### ADDENDUM NO. 1

# REMODELING FOR LIVING QUARTERS AT TOWN OF LINN FIRE/EMS STATION LAKE GENEVA, WISCONSIN

ADDENDUM NO. 1 DATED: April 25, 2024

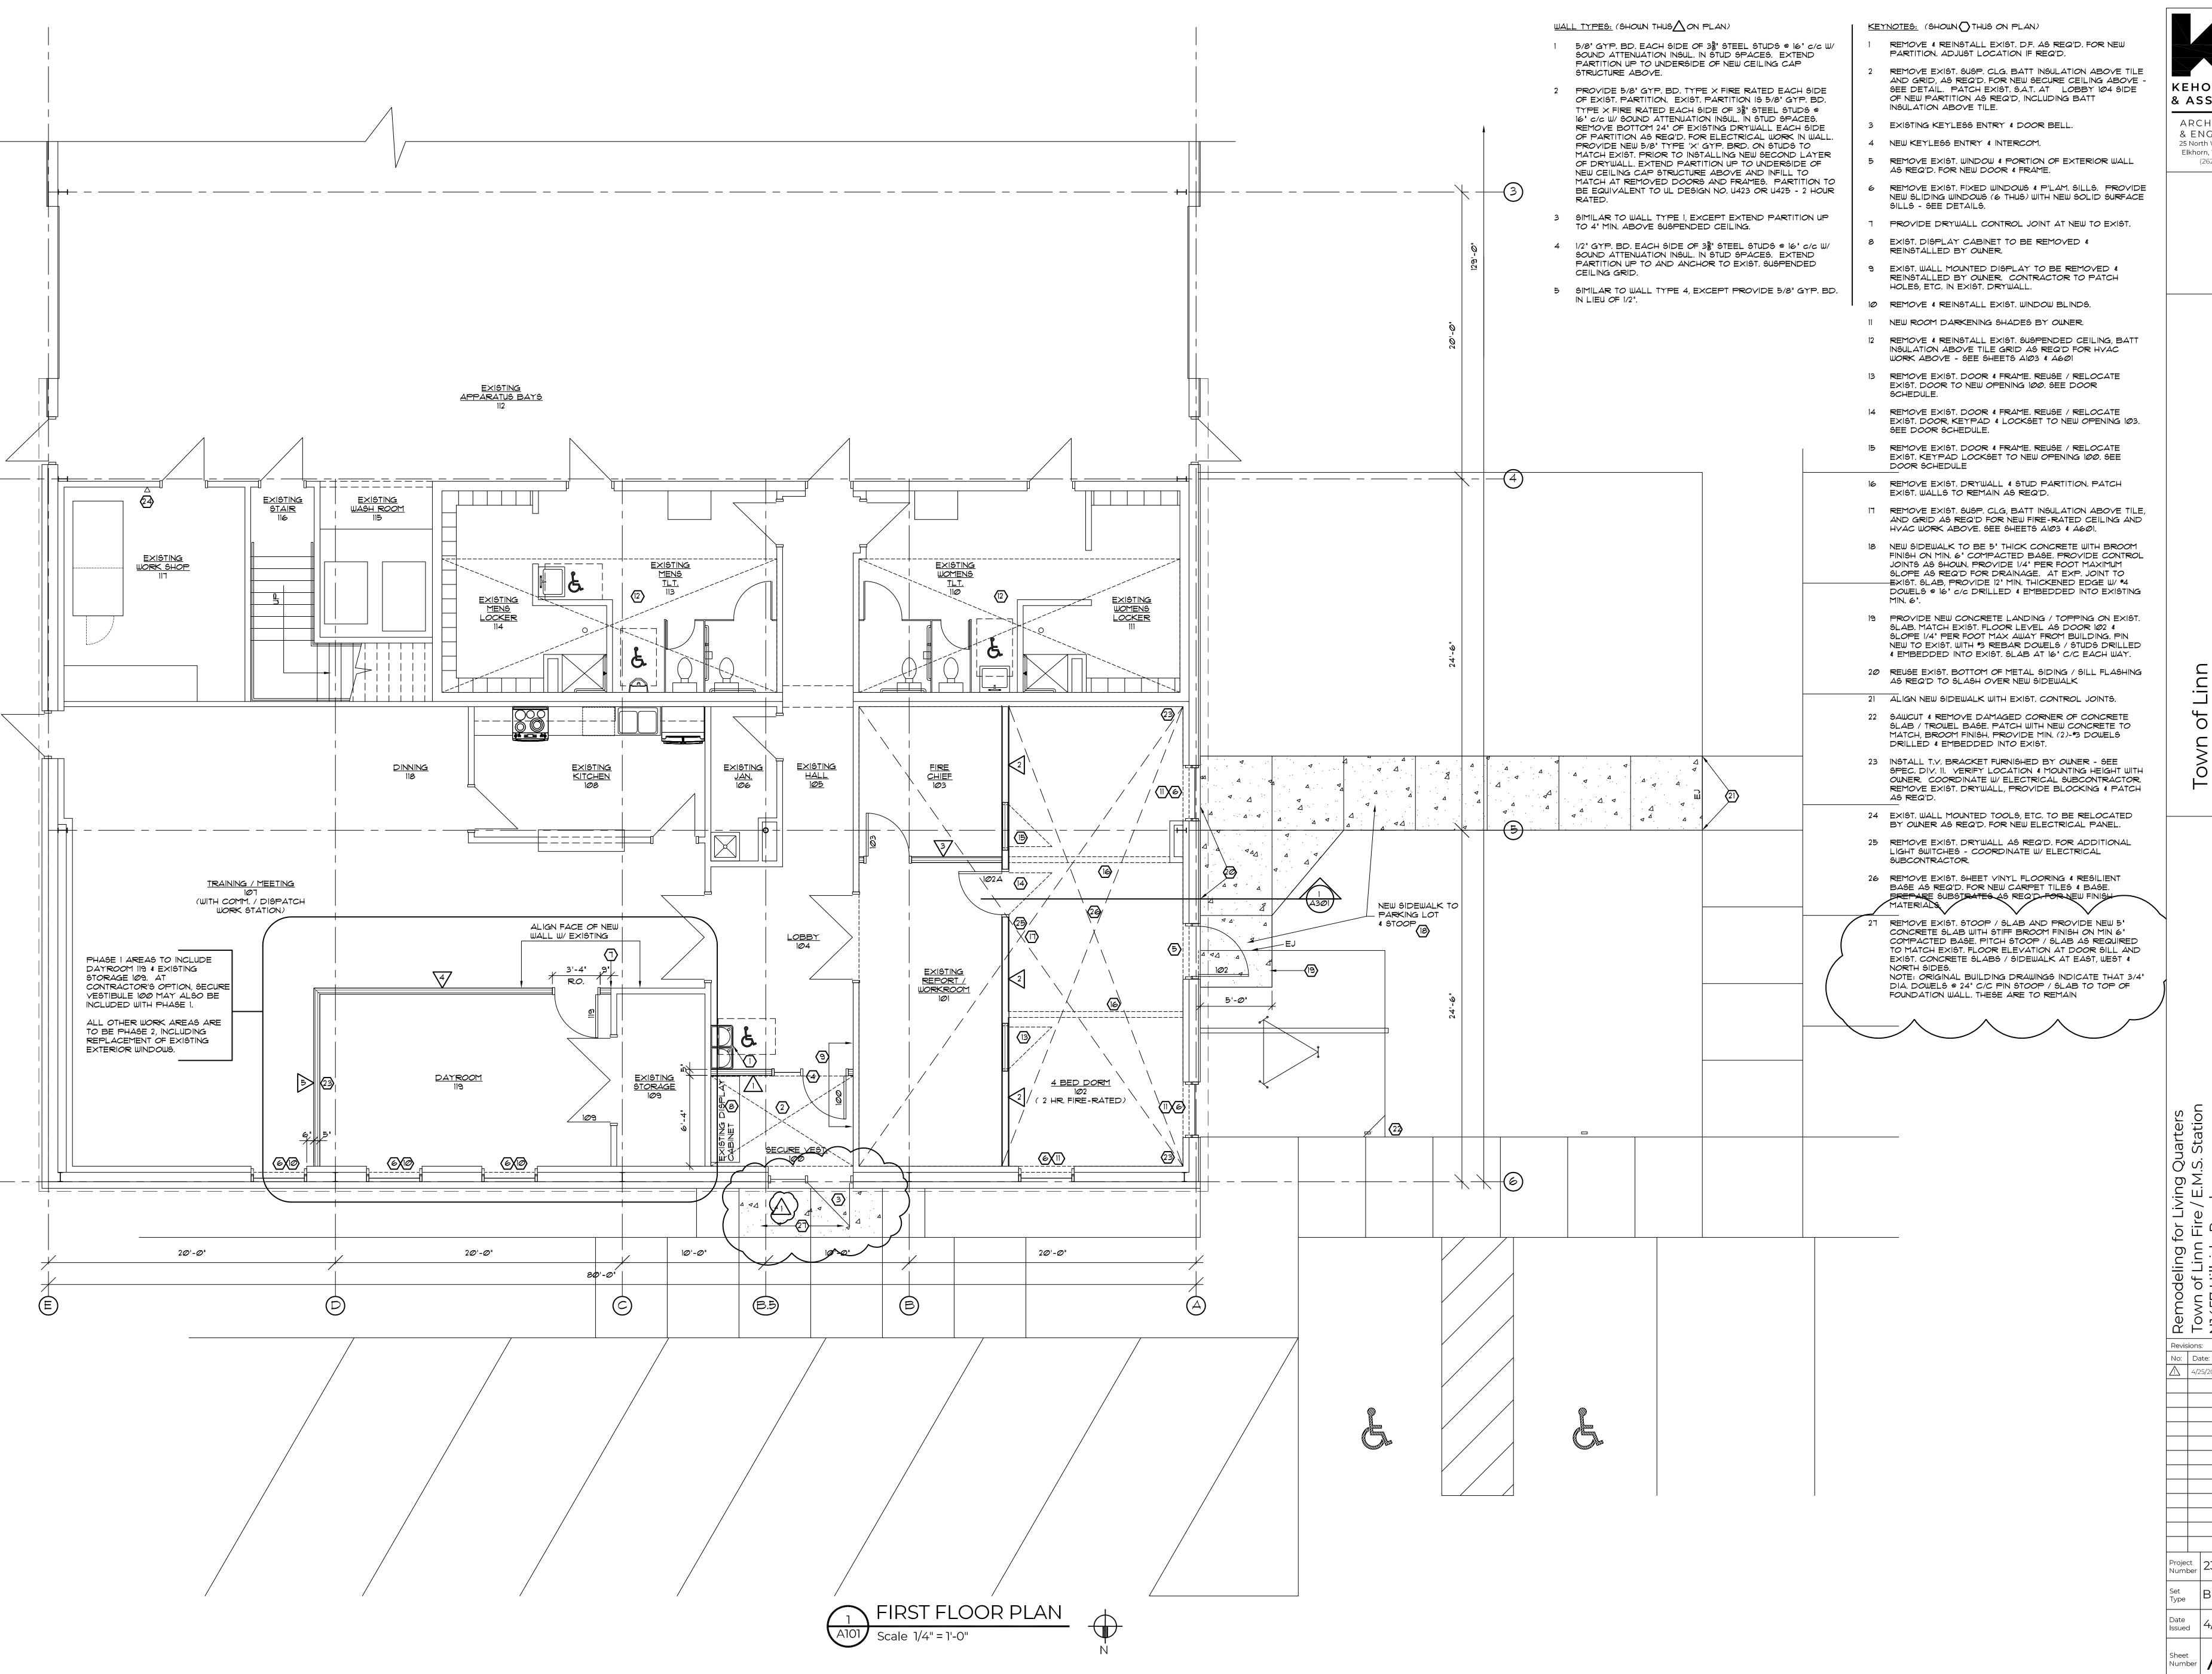
1	SPECIFICATIONS ADDENDUM				
2 3	INSTRUCTIONS TO BIDDERS				
4 5	Page ITB-3; Line No. 17: Add new subparagraph A.1) as follows.				
6 7	1) A list of attendees at the Pre-Bid Conference is included herewith.				
8 9					
10 11	<u>DRAWINGS ADDENDUM</u>				
12	SHEET A101 - FIRST FLOOR PLAN				
13 14	1/A101 - First Floor Plan:				
15 16	See attached partial plan for replacement of existing stoop/slab at main entry door				
17 18	SHEET A601 - ROOM & DOOR SCHEDULE/DETAILS				
19 20	<b>Door Schedule:</b>				
21 22 23 24	Clarification: Doors and Frame 109 are existing to remain, along with existing hardware. Provide new door transfer grilles in existing doors and paint existing HM frame and DTGs.
